**Re: Lot 1 Block 2 Unit 18 Volcano Cliffs, S.A.D. 228
6616 Petirrojo NW
Request for Permanent C.O. – Not Accepted
Engineer's Stamp dated: 2-19-18 (D10D003G1)
Certification dated: 10/23/18**

Based on the Certification received 10/23/18, this site cannot be accepted for release of Certificate of Occupancy by Hydrology until the following comments are addressed.

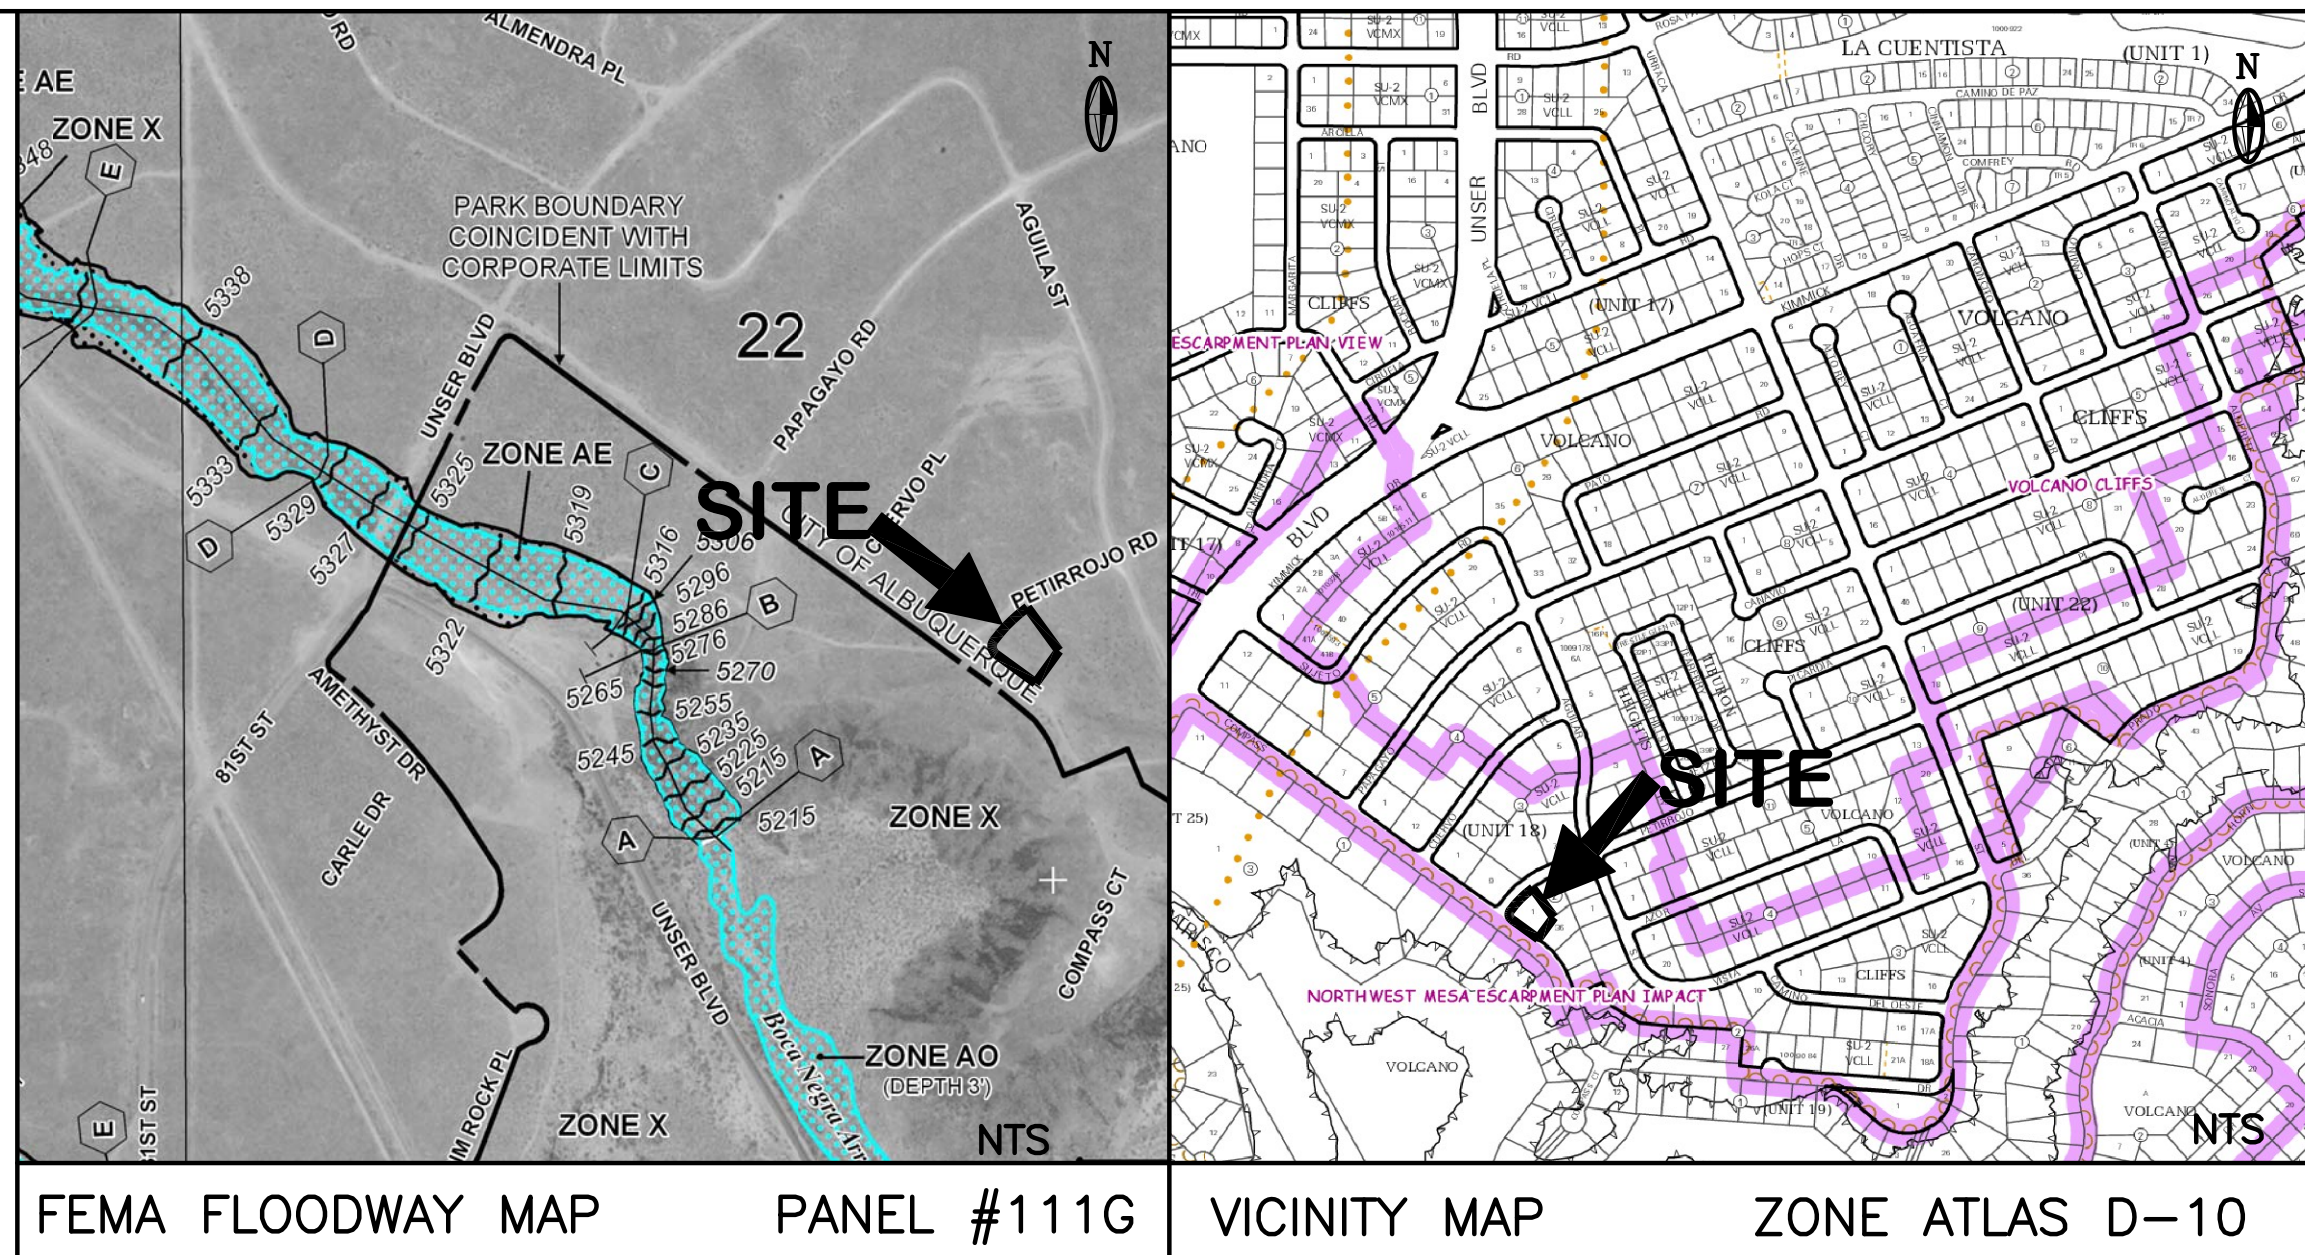
- Remove dirt from used as a ramp in street and sidewalk.
- Provide how the raised lot will be protected from erosion on the North and west sides of the property line.
- Prevent the flows from entering Compass Dr. at the S.E. corner of the lot. All flows must enter the retention pond before flowing out into the public right of way.
- Remove the debris pile and the container from the lot to the north.
